Value Engineering Study
***US 127 FROM KY 90 TO
JAMESTOWN BYPASS***
CLINTON & RUSSELL COUNTY, KENTUCKY

***ITEM NUMBER 8-108.00 & 8-115.10
VE STUDY NUMBER 201102***

Study Date: February 28 -
March 4, 2011

Final Report

VALUE ENGINEERING RECOMMENDATION # VE-16

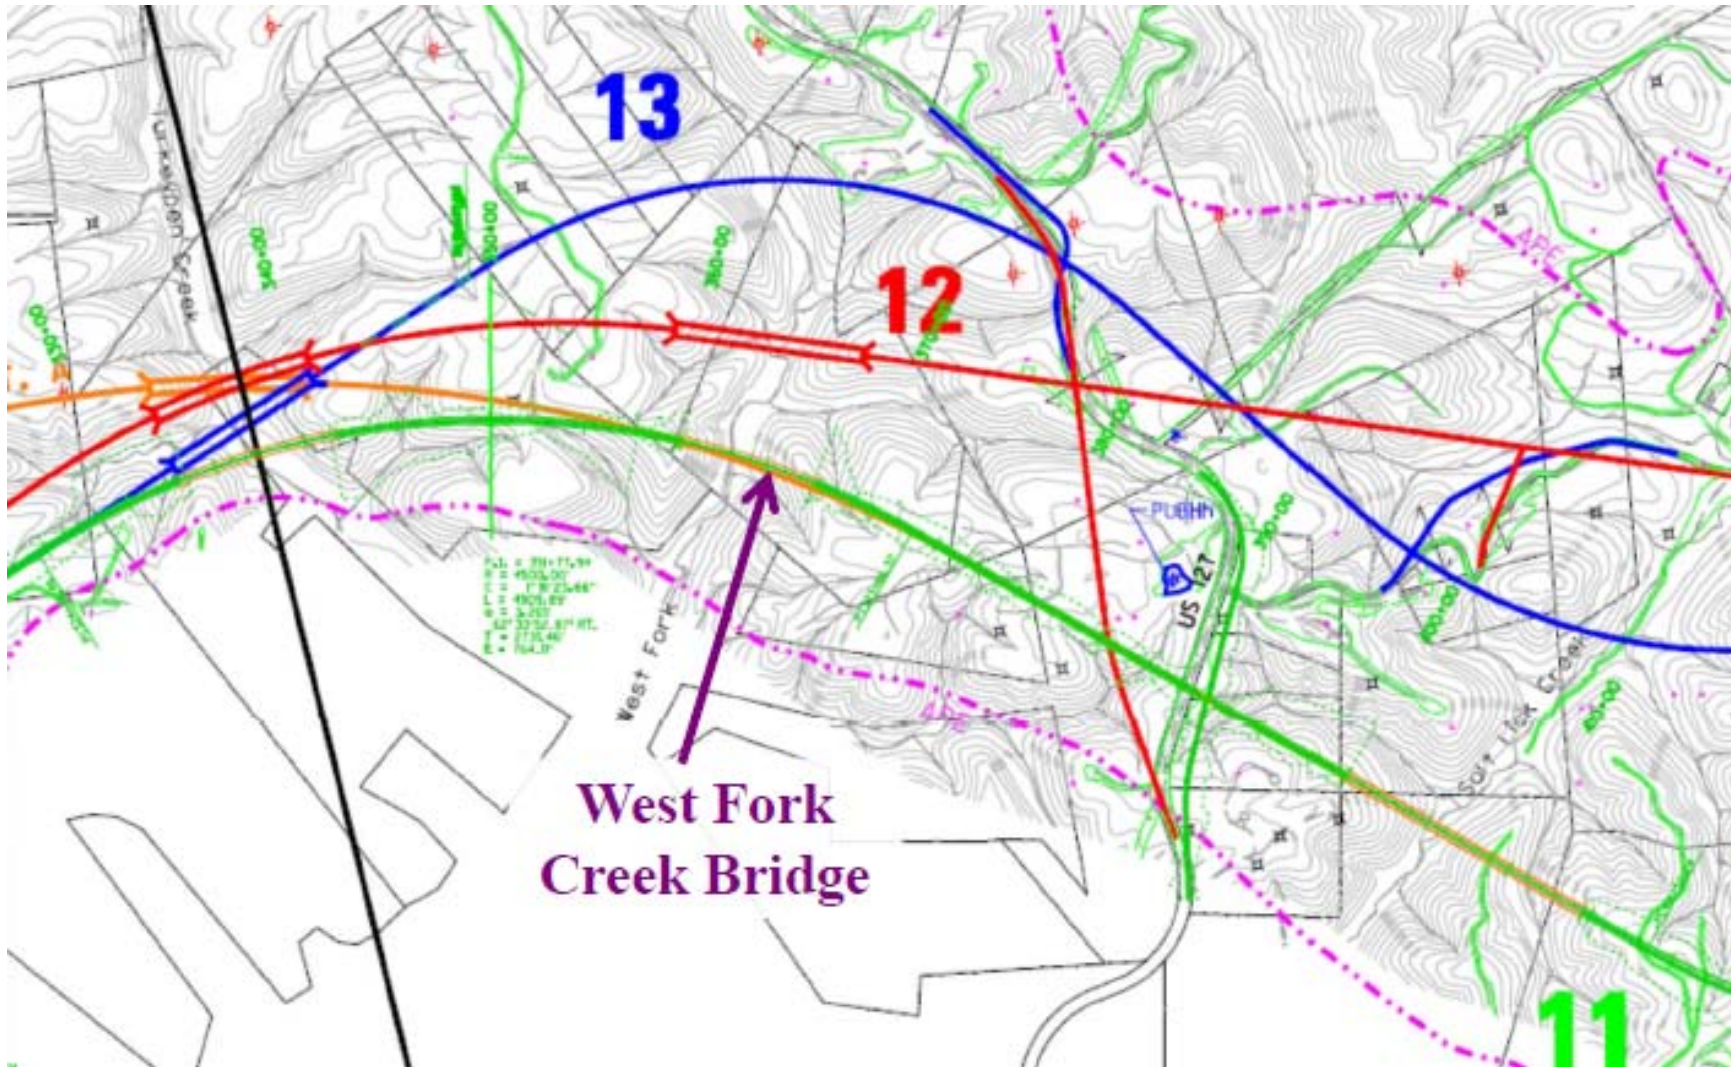
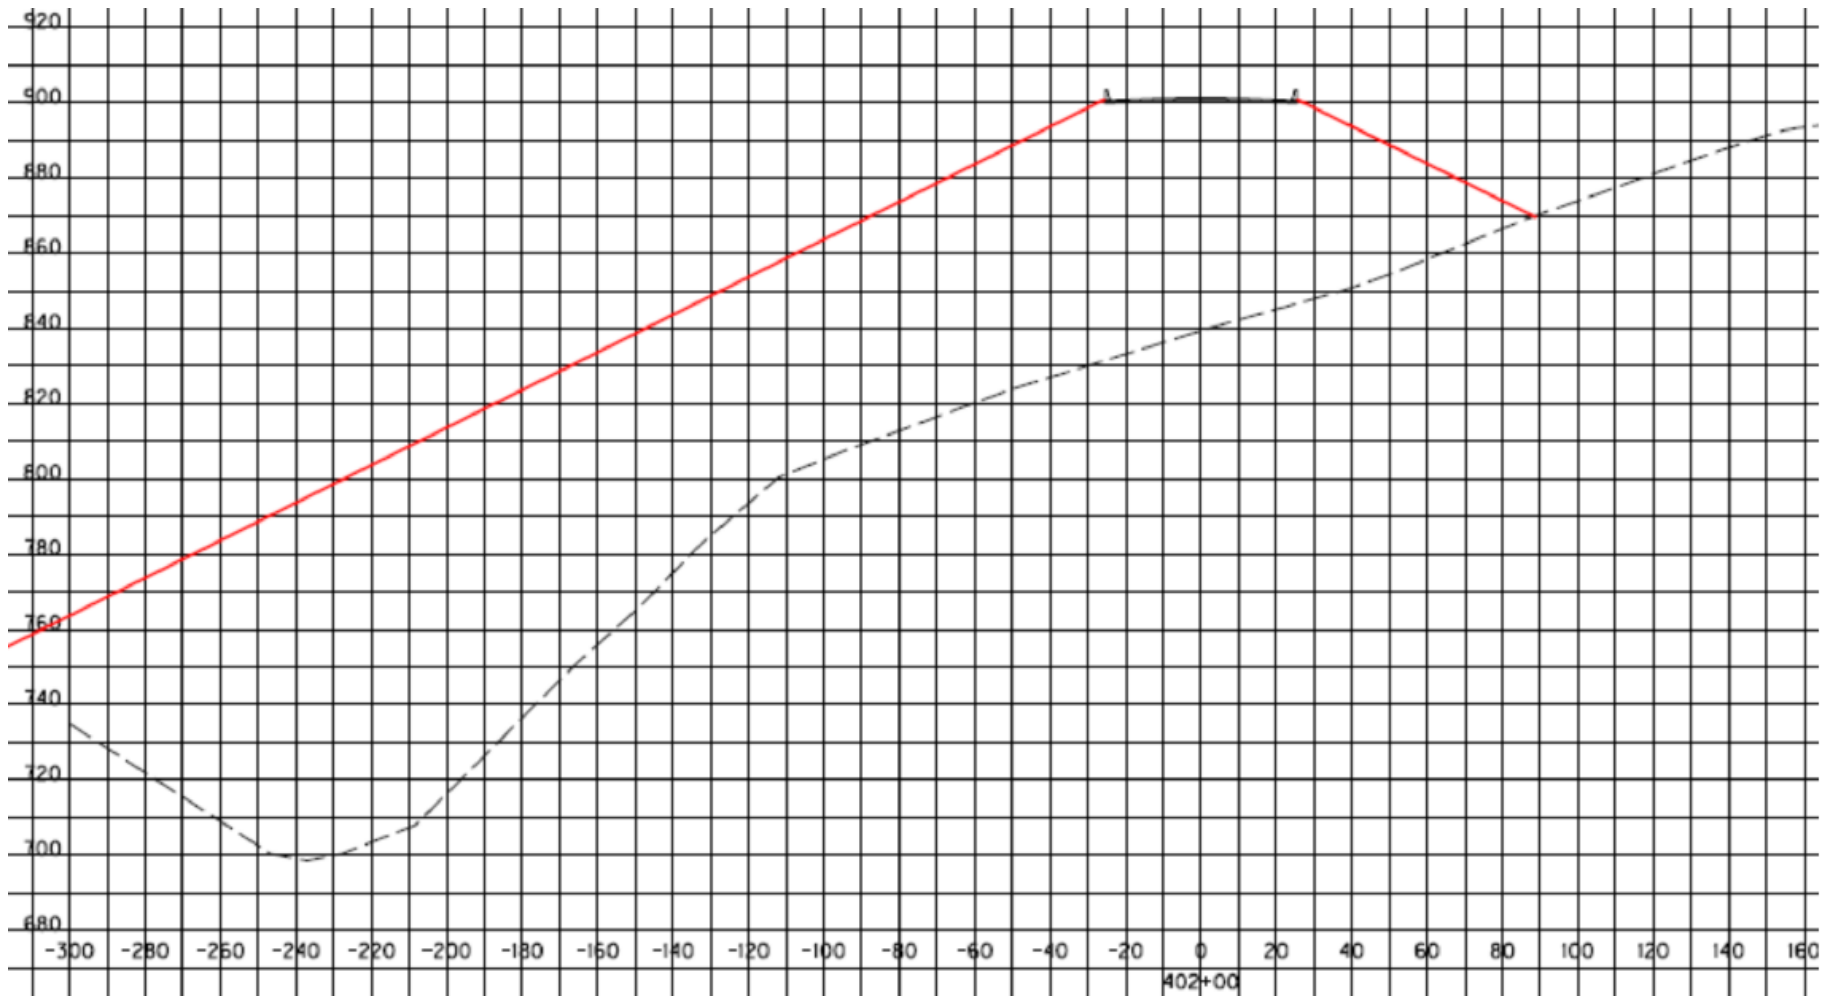
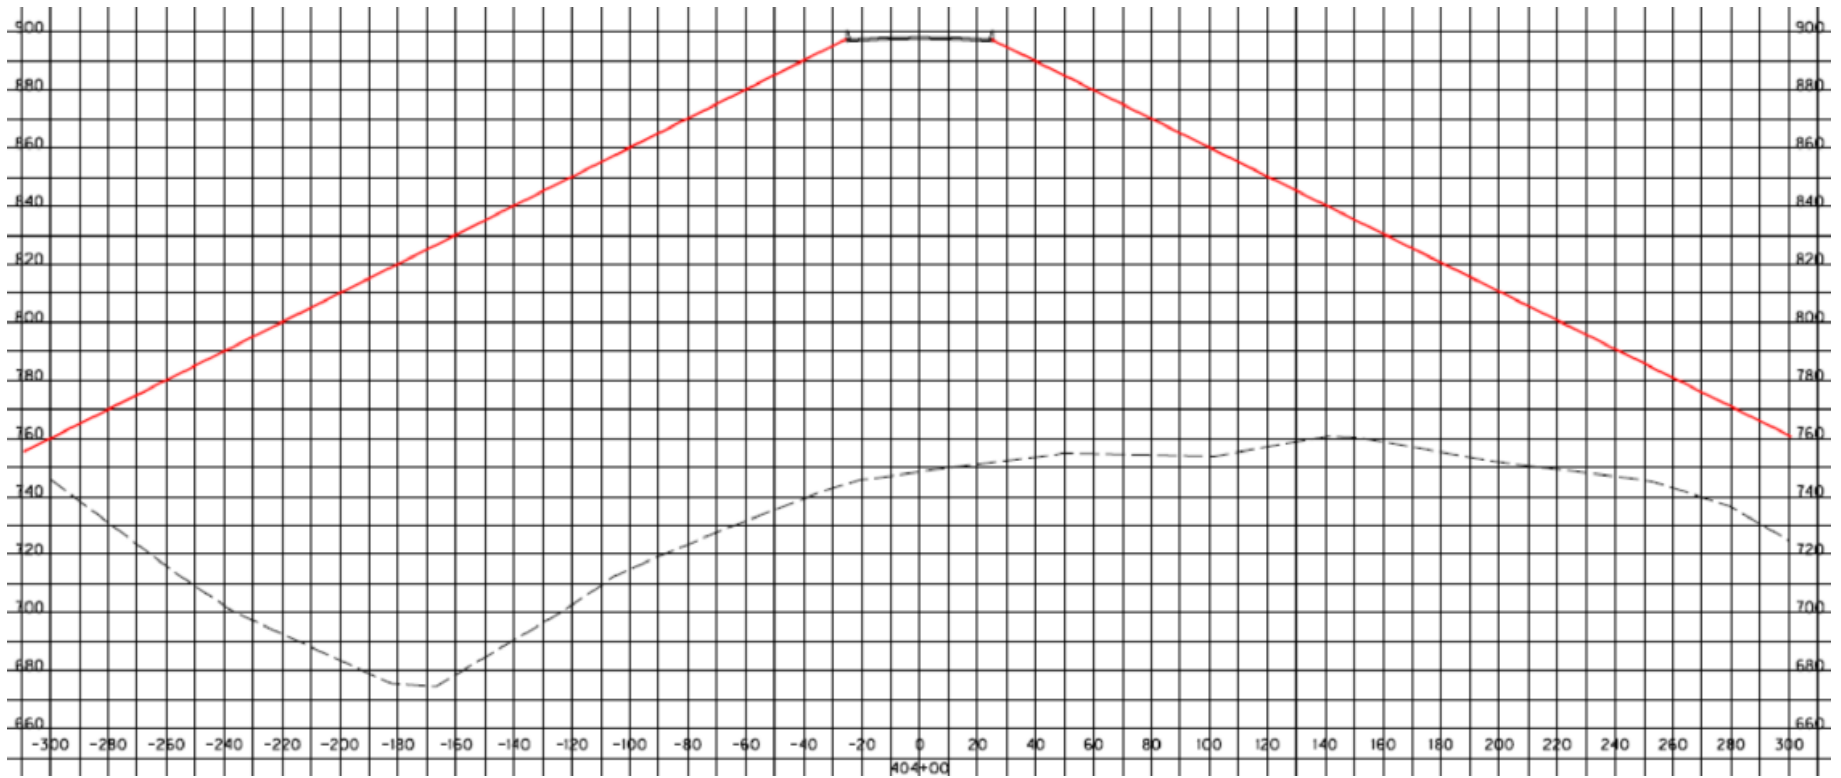
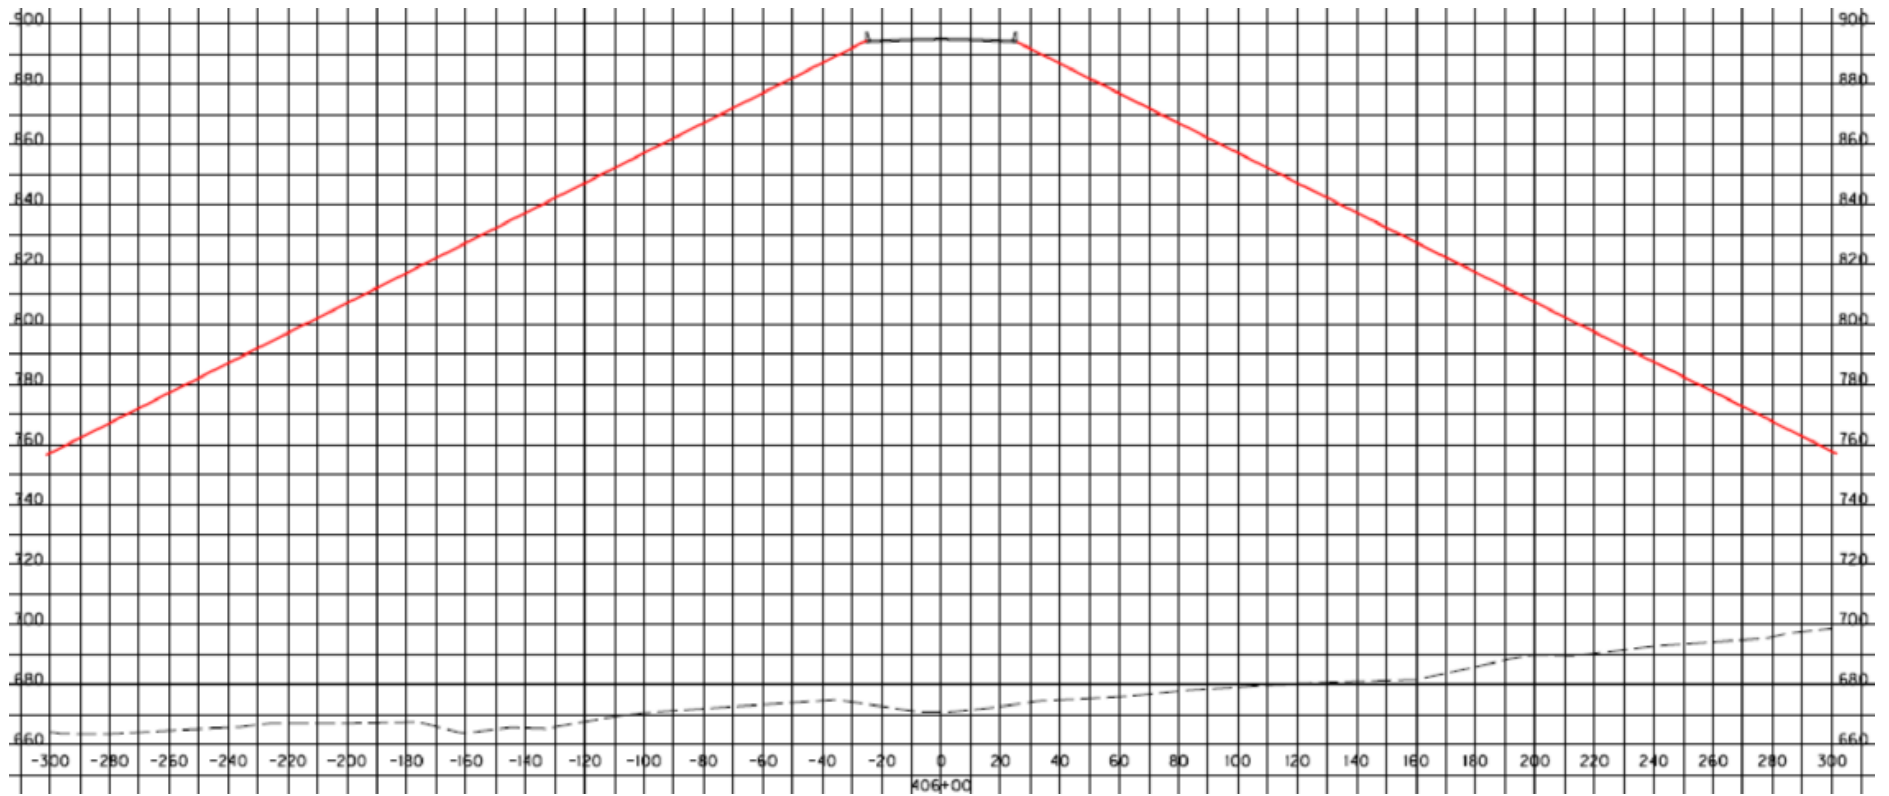
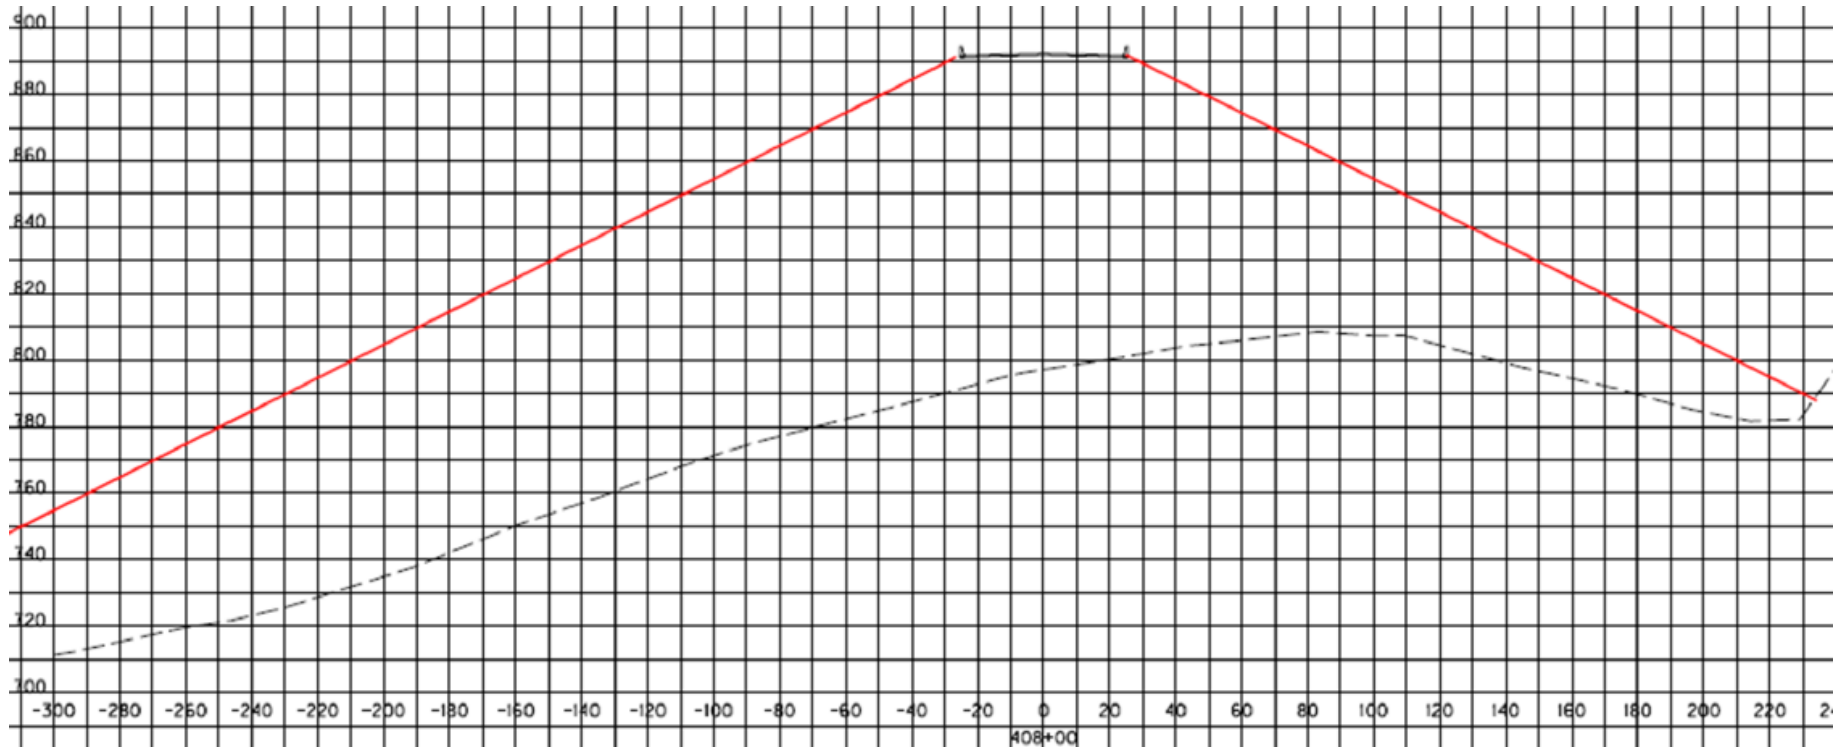
The original design specifies a bridge spanning West Fork Creek and the associated valley. Based on preliminary recommendations the estimated bridge length is 753 feet with a 51 foot bridge width. The valley at this location is approximately 200 feet below the profile grade for US 127. Based on the required pier height for this structure the VE team revised the project team’s square foot costs for the bridge to \$275 per square foot from \$105 per square foot to reflect the increased span lengths and complexity of constructing tall piers.

The revised initial construction costs are significantly reduced by eliminating the proposed structure in lieu of a culvert structure and embankment. A secondary benefit would be the elimination of future deck overlays/replacement, painting, and other bridge maintenance items. This VE proposal assumes a fill cost of \$6 per square foot. While not studied as part of this recommendation, adjusting the profile to reduce the depth of fills and better balance the overall cut fill for the project would increase the benefit of this VE recommendation.
